REPORT TO COUNCIL

Application: DP15-0173, DVP15-0174 **Owner:** Windmill Ventures Ltd.,
Inc.No. BC0686196 &
0797989 B.C. Ltd., Inc. No.
BC0797989

Address: 332 Lake Ave **Applicant:** DiStefano Architecture

Subject: Development Permit and Development Variance Permit

Figure 2: Proposed Surface Parking Lot

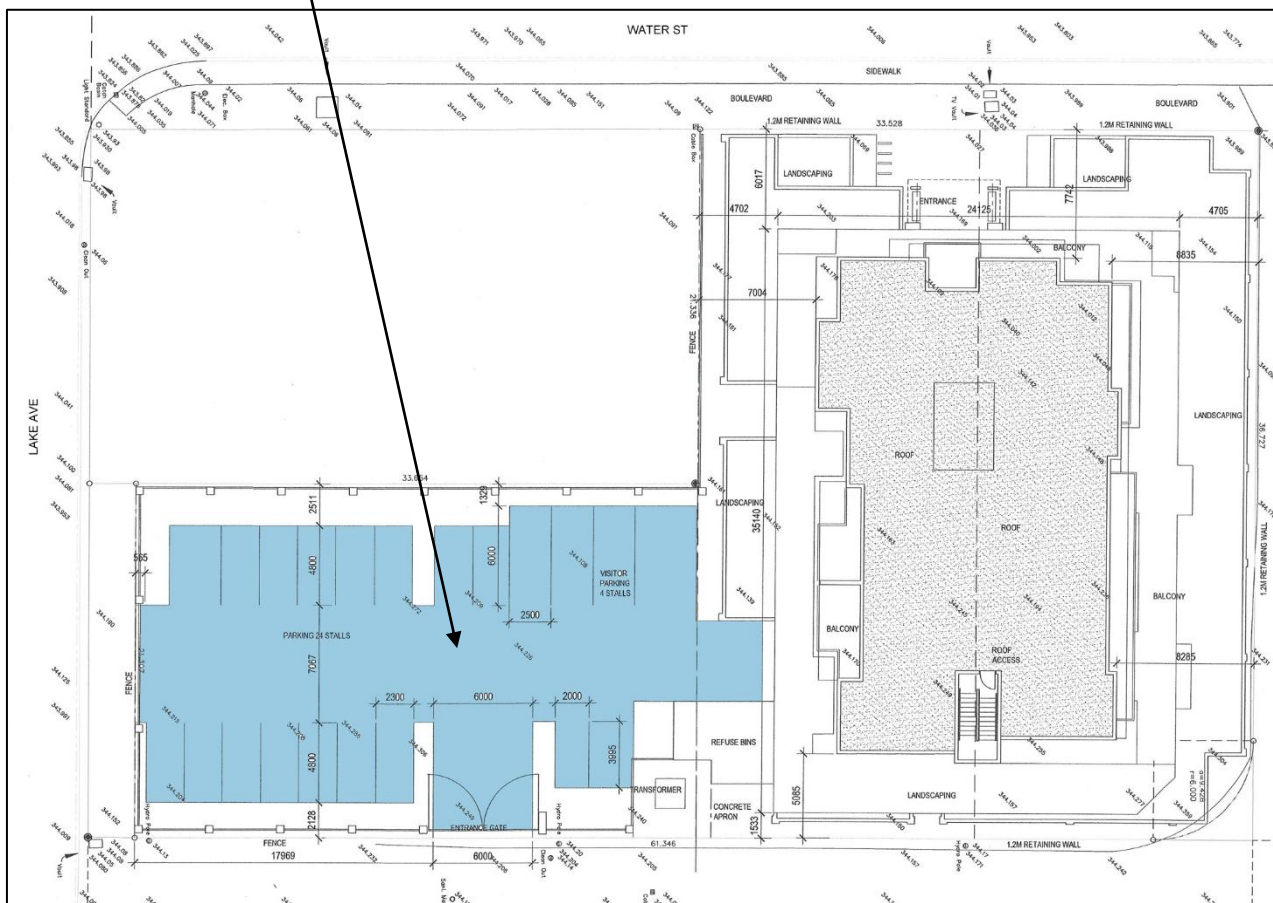
Further, the OCP Urban Design Guidelines discourage the construction of surface parking lots fronting Lake Ave. The proposal under consideration is contrary to this policy as the site plan proposes a surface parking lot fronting Lake Avenue. The surface parking lot prevents a streetscape rhythm of buildings to be established and would further erode the character of the neighbourhood.

Figure 3: Proposed Water Street Elevation

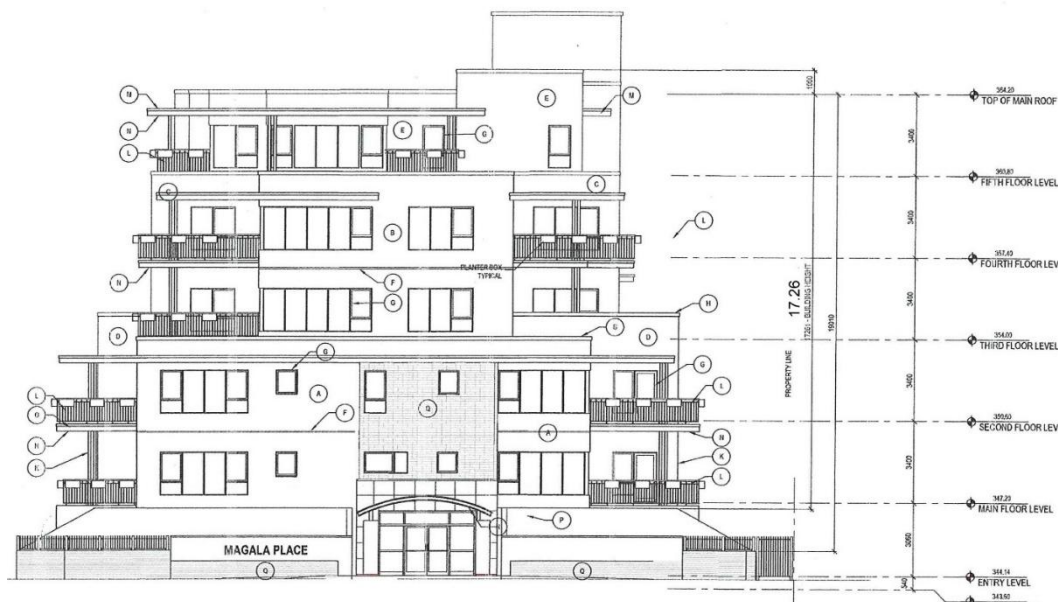
The applicant suggested that the architecture is inspired by one of the early modern Art Deco homes in the Abbott Street neighbourhood. However, the adaptation is challenged by applying a single family residential style of architecture to a much larger scale multi-family building. The relevance of this inspiration is questionable as the dominant form of the single family homes along Water Street immediately to the west of the development is bungalow style with pitched roofs. A more sensitive approach to building design would have considered the style of the immediate neighbourhood.
